# PRELIMINARY INFORMATION SHEET

PROJECT NAME: BENNINGTON  
 PROJECT NUMBER: ER BHF 010-1(45)  
 FILE NAME: z11b326\_pl.xls PLOT DATE: 8/21/2012  
 PROJECT LEADER: DEG DRAWN BY: KJK  
 DESIGNED BY: BTH CHECKED BY: SAW  
 PRELIMINARY INFORMATION SHEET SHEET 2 OF 40

THIS PROJECT INVOLVES THE RETROFITTING OF THE VERMONT ROUTE 9 BRIDGE 9 PIER FOUNDATIONS WITH MICROPILES IN THE TOWN OF BENNINGTON. THIS PROJECT DOES NOT INCLUDE ANY BRIDGE OR ROADWAY PAVEMENT REHABILITATION. THIS PROJECT WILL INVOLVE THE CONSTRUCTION OF TWO TEMPORARY ACCESS ROADS FROM VERMONT ROUTE 9 TO EITHER BRIDGE PIER.

<b>EROSION CONTROL STAGE 2 PLAN SHEET</b>	PROJECT NAME: BENNINGTON	PLOT DATE: 9/6/2012
	PROJECT NUMBER: ER BHF 010-I(45)	DRAWN BY: M.E.D.
	FILE NAME: z11b326_erccp_stg2.dgn	DESIGNED BY: B.T.H.
	DWG. NO.: z11b326ec2.1	CHECKED BY: D.E.G.
		SHEET 12 OF 40

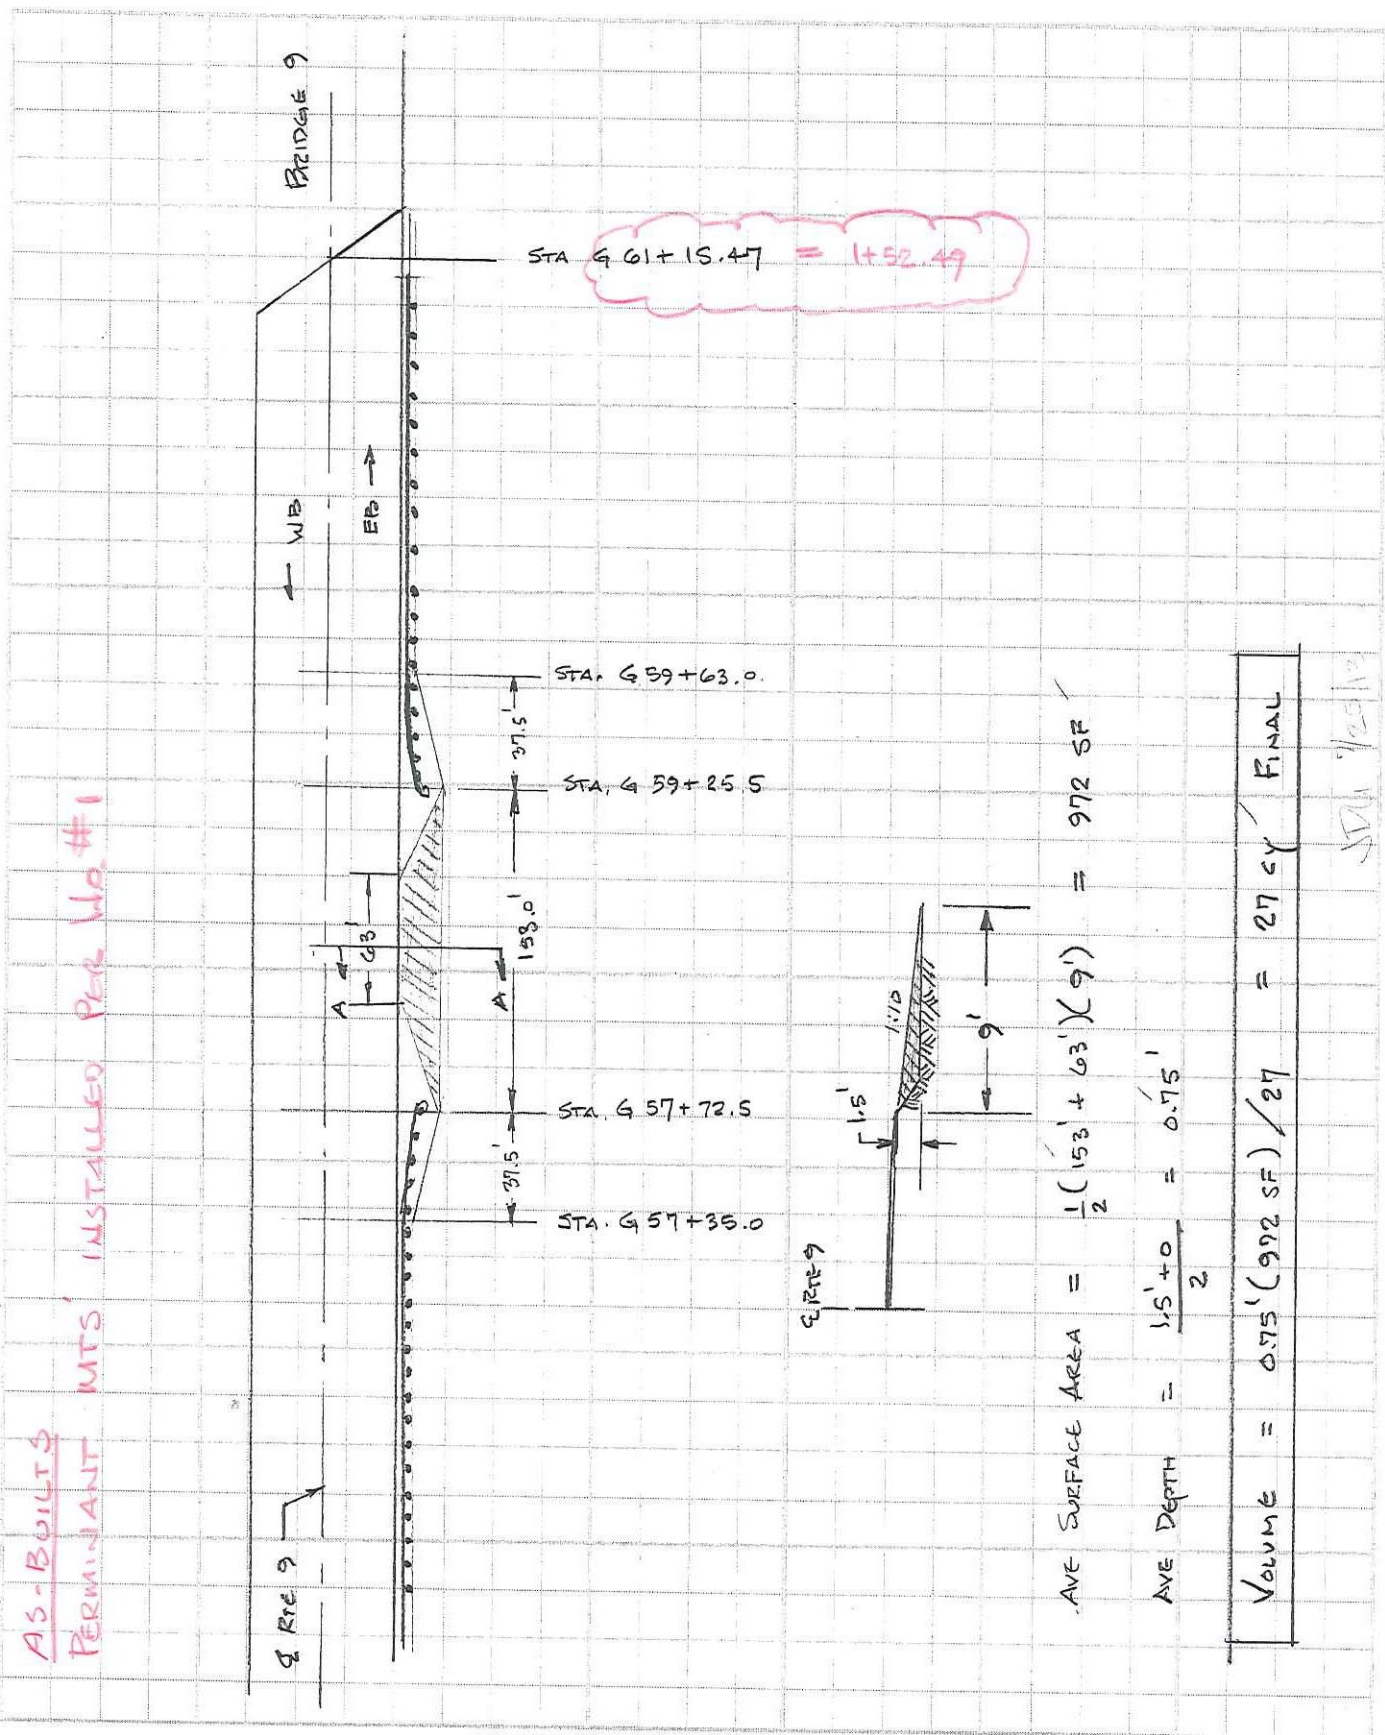
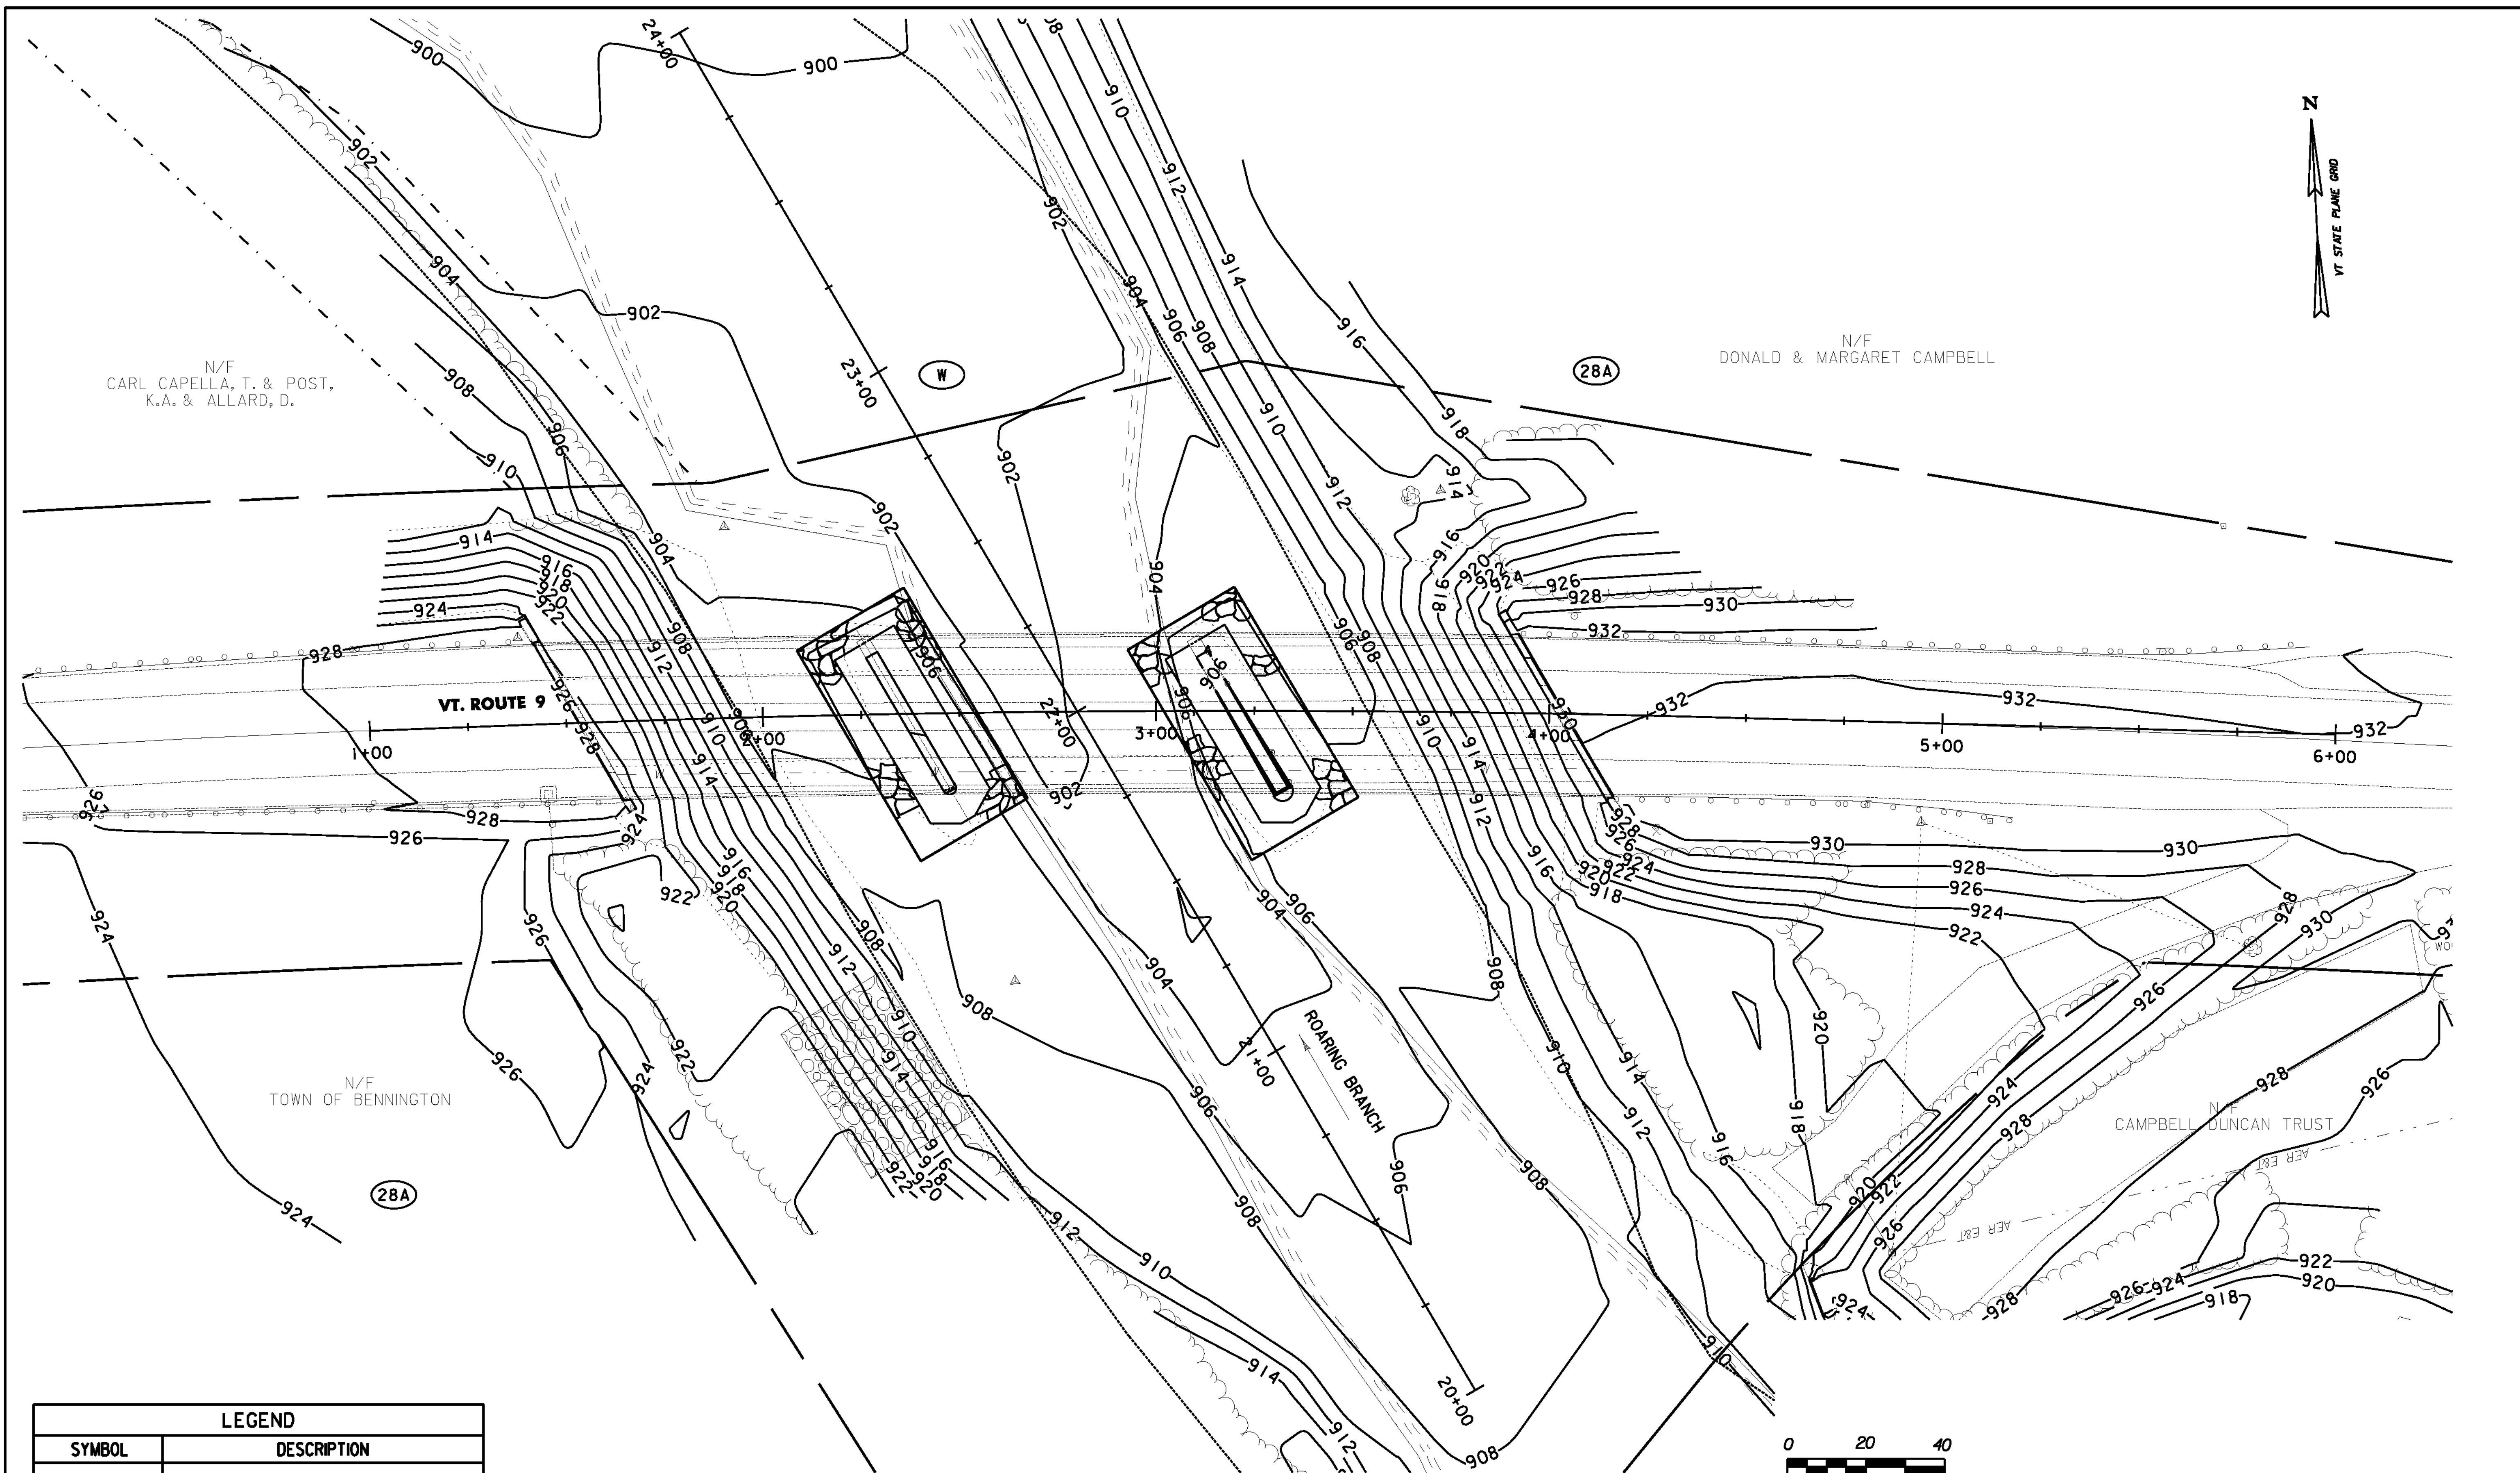
Project Bennington ER BHF 010-1(45) Calculation Sheet Number \_\_\_\_\_  
 Line Item # 301.35 Page Number \_\_\_\_\_ of \_\_\_\_\_  
 Item # 0060 Field Measured by R. DEMEY  
 Item Description SUBBASE OF DENSE GRADED CRUSHED STONE  
 Location STAGE II ACCESS (RTE 9 OPENING) Date 7-16-13

<b>PROJECT NOTES SHEET</b>	PROJECT NAME: BENNINGTON	
	PROJECT NUMBER: ER BHF 010-I(45)	
	FILE NAME: z11b326_gn.dgn	PLOT DATE: 8/21/2012
	PROJECT LEADER: D.E.G. DESIGNED BY: K.J.K. DWG. NO.: z11b326gn.1	DRAWN BY: M.E.D. CHECKED BY: A.M.P. SHEET 25 OF 40

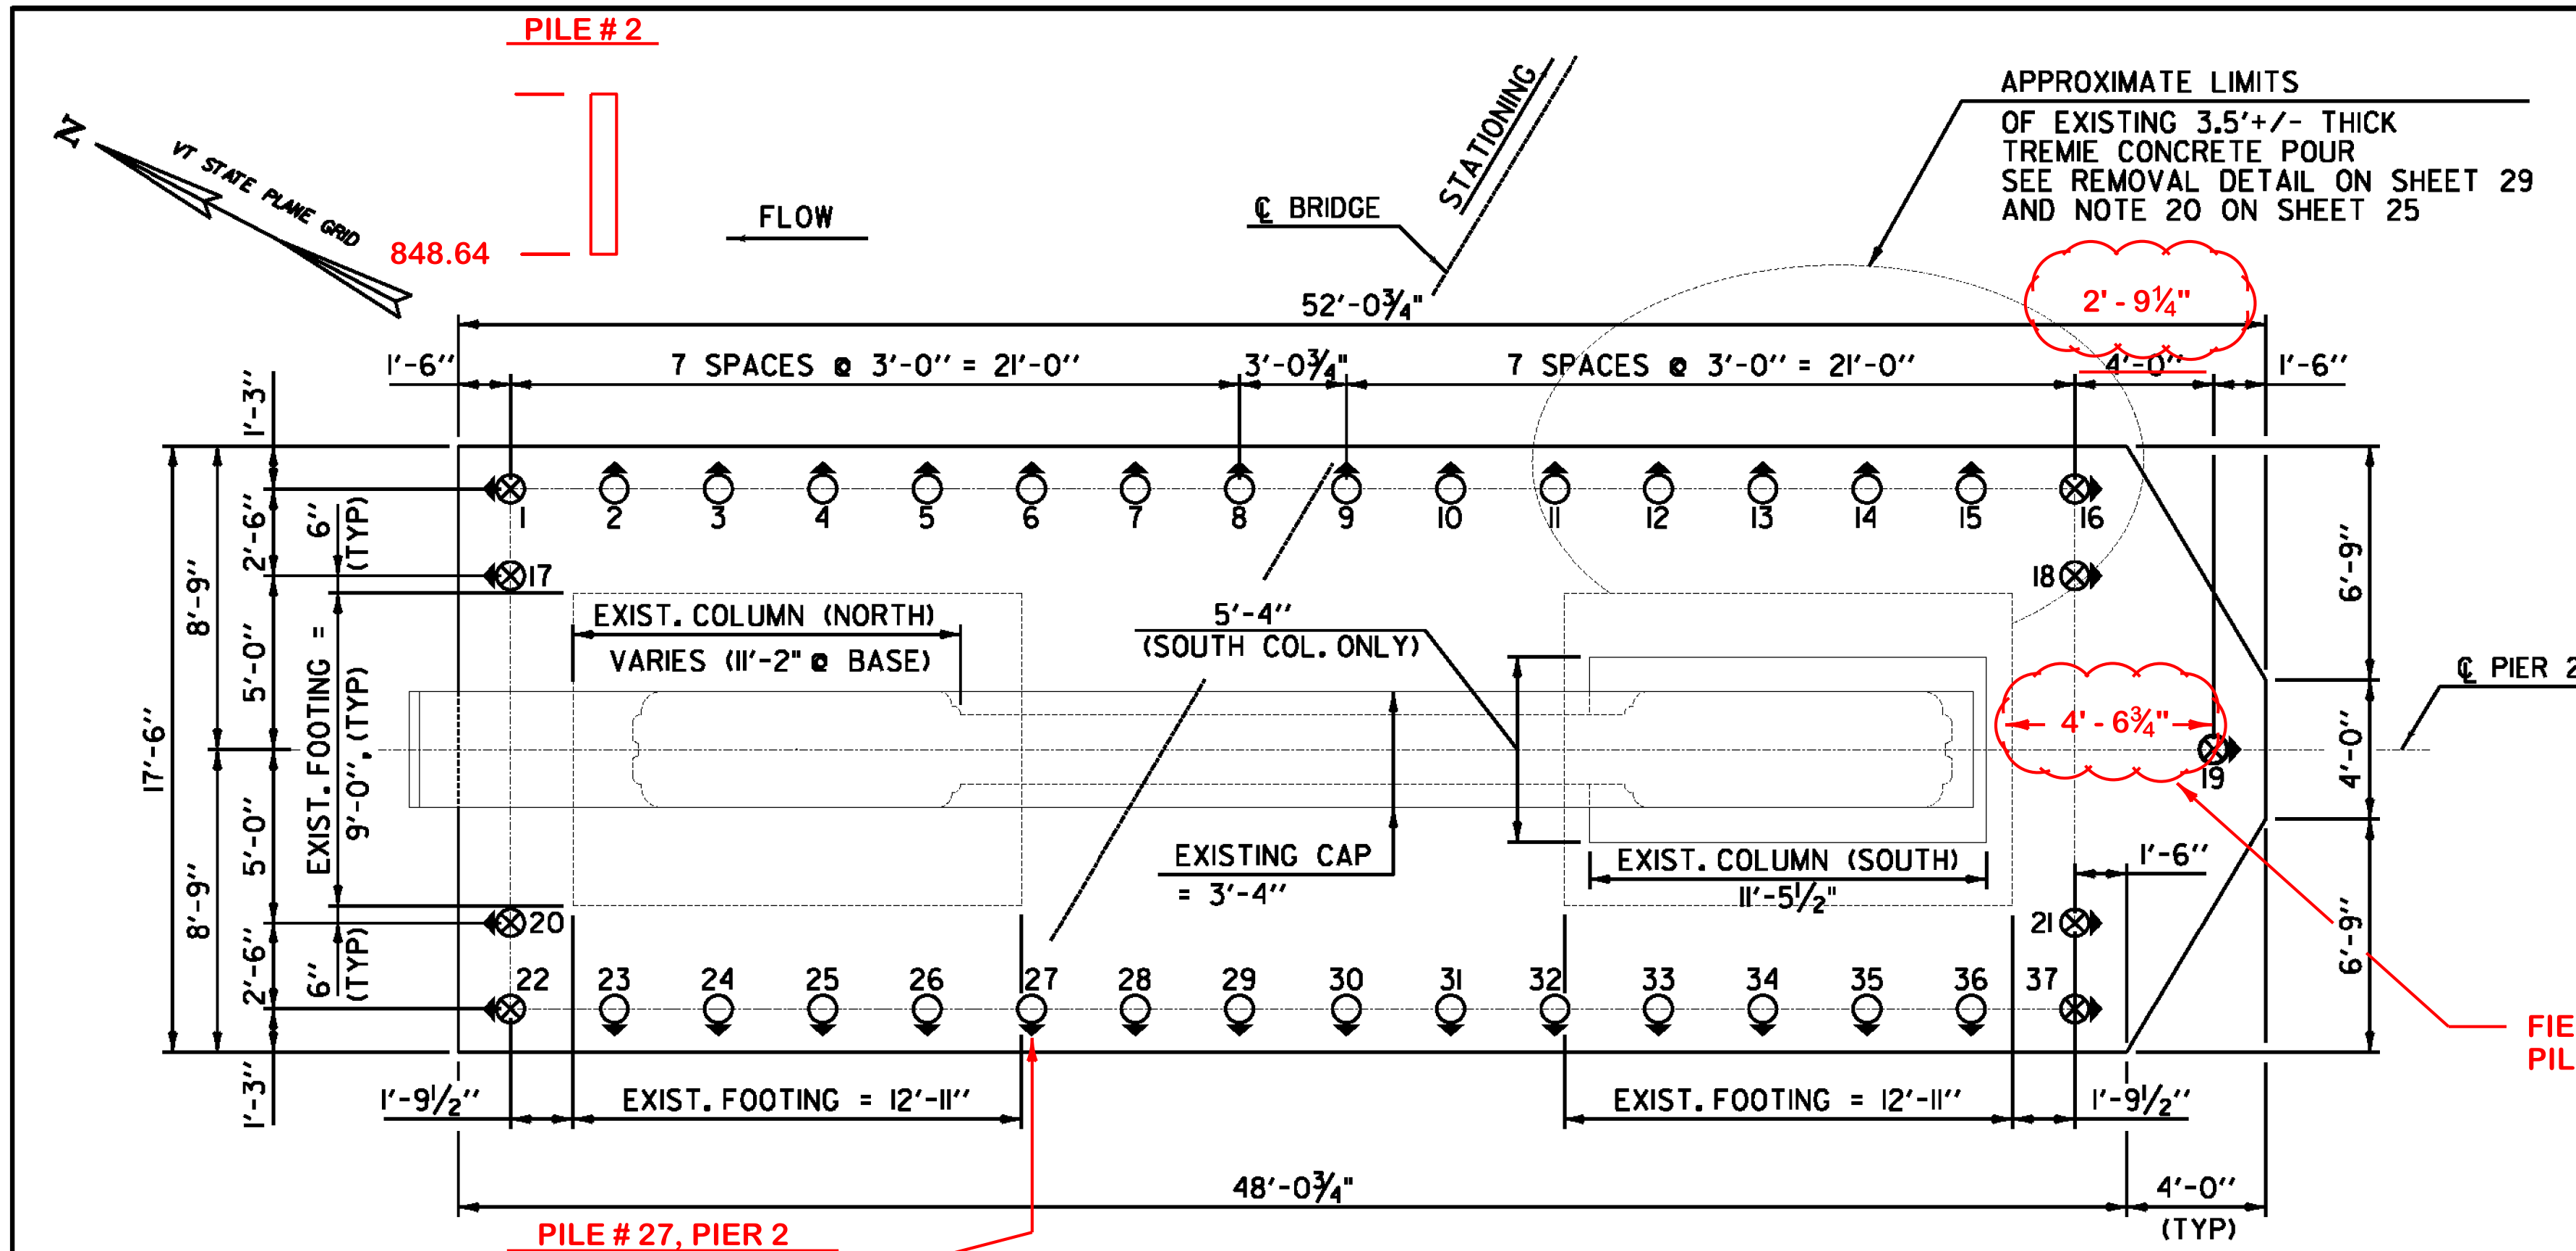
PER RESPONSE TO RFI #1 DATED 3-15-2013

$$\frac{\text{STRENGTH LIMIT STATE}}{\text{GEOTECHNICAL RESISTANCE}} = \frac{130 \text{ K}}{0.55} = -236.4$$
